SUBJECT: ISSUANCE OF AMENDMENT NO. 12 TO FACILITY OPERATING LICENSE  
NO. NPF-3 FOR DAVIS-BESSE NUCLEAR POWER STATION, UNIT NO. 1

Amendment No. 12  
License No. NPF-3

ATTACHMENT TO LICENSE AMENDMENT NO. 12

SUPPORTING AMENDMENT NO. 12 TO LICENSE NO. NPF-3

DAVIS-BESSE NUCLEAR POWER STATION  
UNIT No. 1  
OFF SITE ORGANIZATION CHART  
FIGURE 6.2-1

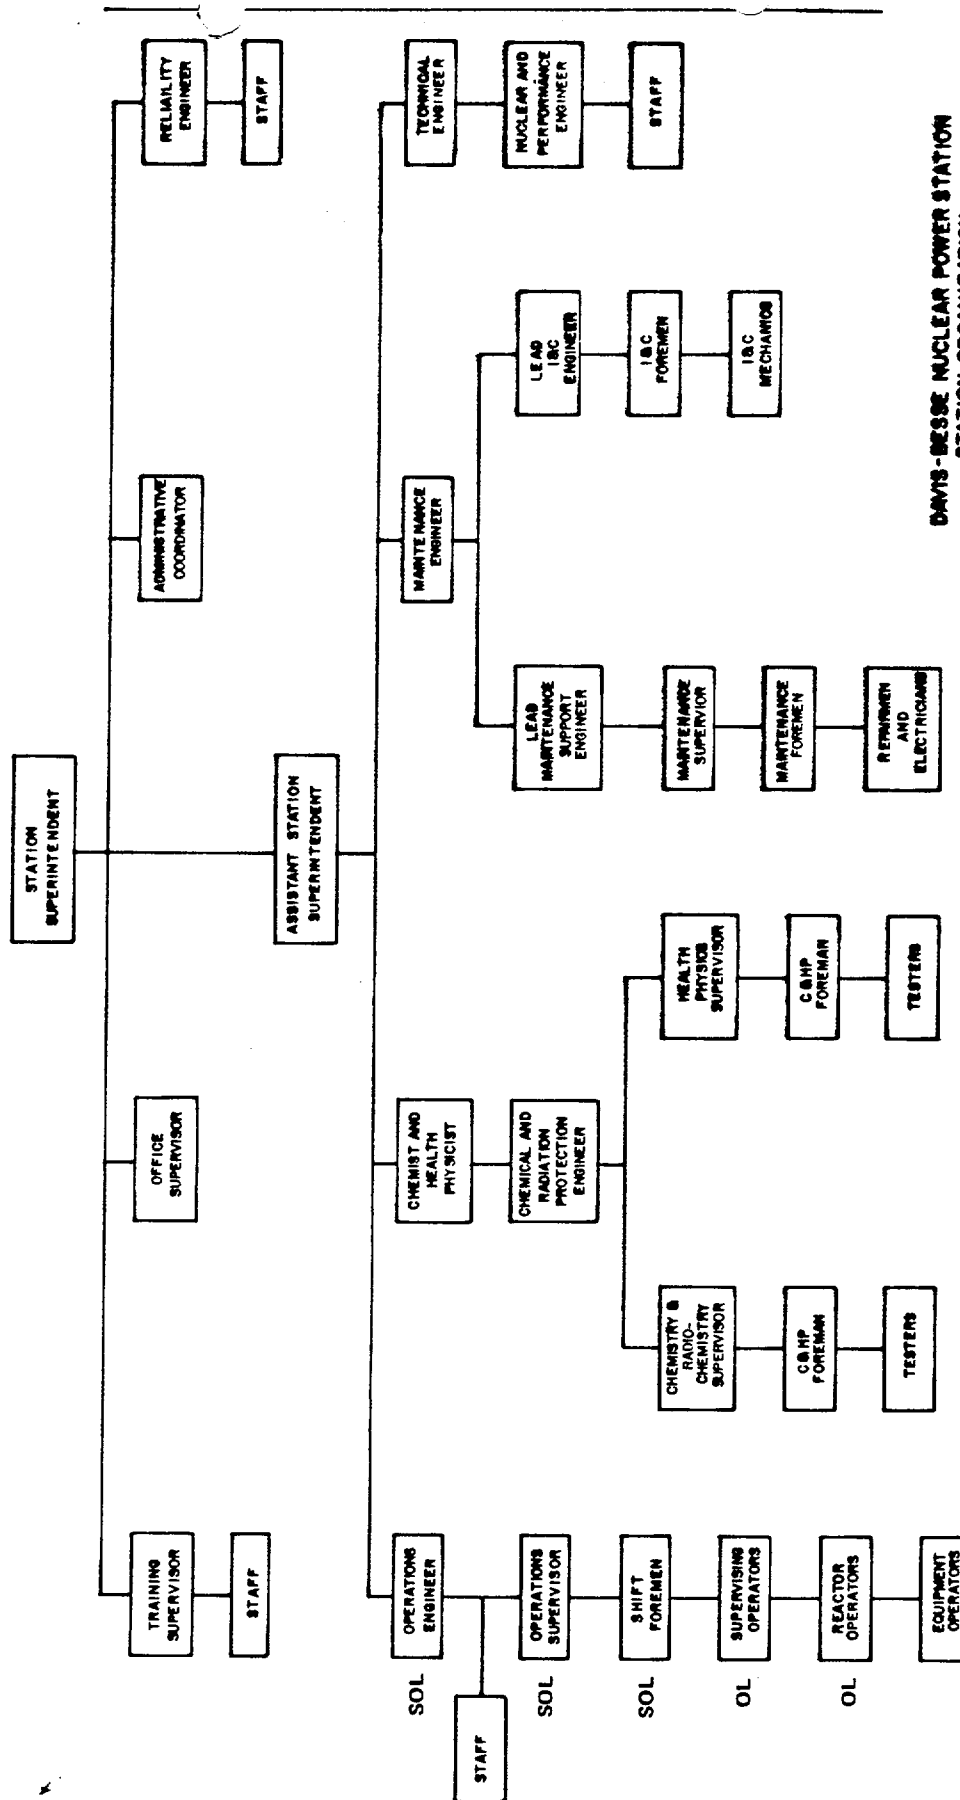
2. On June 12, 1978, the Toledo Edison Company informed us that changes were being made at the corporate level entailing a new reporting change for the Vice President, Energy Supply, and for the Company Nuclear Review Board. At the station level they include the establishment of the new positions of Assistant Station Superintendent, and Chemical and Radiations Protection Engineer. The Station Operations Engineer, Chemist and Health Physicist, Maintenance Engineer, and Technical Engineer report to the new position of Assistant Station Superintendent. The requested changes are delineated in Pages 6-6, 6-9, 6-11, and 6-12 and also Figures 6.2-1 and 6.2-2 of the Technical Specifications.

2. On June 12, 1978, the Toledo Edison Company informed us that changes were being made at the corporate level entailing a new reporting change for the Vice President, Energy Supply, and for the Company Nuclear Review Board. At the station level they include the establishment of the new positions of Assistant Station Superintendent, and Chemical and Radiations Protection Engineer. The Station Operations Engineer, Chemist and Health Physicist, Maintenance Engineer, and Technical Engineer report to the new position of Assistant Station Superintendent. The requested change are delineated in Pages 6-6, 6-9, 6-11, and 6-12 and also Figures 6.2-1 and 6.2-2 of the Technical Specifications.

6.2.1 The offsite organization for facility management and technical support shall be as shown on Figure 6.2-1.

6.2.2 The Facility organization shall be as shown on Figure 6.2-2 and:
